SERVICE BULLETIN

SERVICE BULLETIN	**No.:** MSB-00E23-002		
	Date: 2001-02-28	**<Model>**	**<M/Y>**
Subject: ADOPTION OF SOLENOID VALVE HARNESS WITH INTEGRAL TYPE OIL TEMPERATURE SENSOR		ALL	01-01
Group: AUTOMATIC TRANSMISSION	**Draft No.:** 00AT600310		
INFORMATION	**INTERNATIONAL CAR ADMINISTRATION OFFICE**	T.MASAKI – MANAGER TECHNICAL SERVICE PLANNING

5. Change Details:

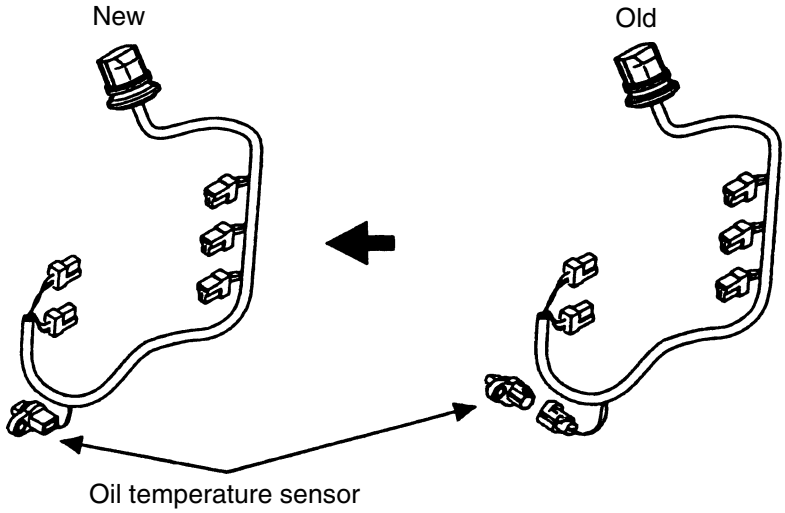
For the automatic transmission on the front-engine front-wheel (E-W) drive cars, the solenoid valve harness with a separate type oil temperature sensor has been changed to that with an integral type oil temperature.
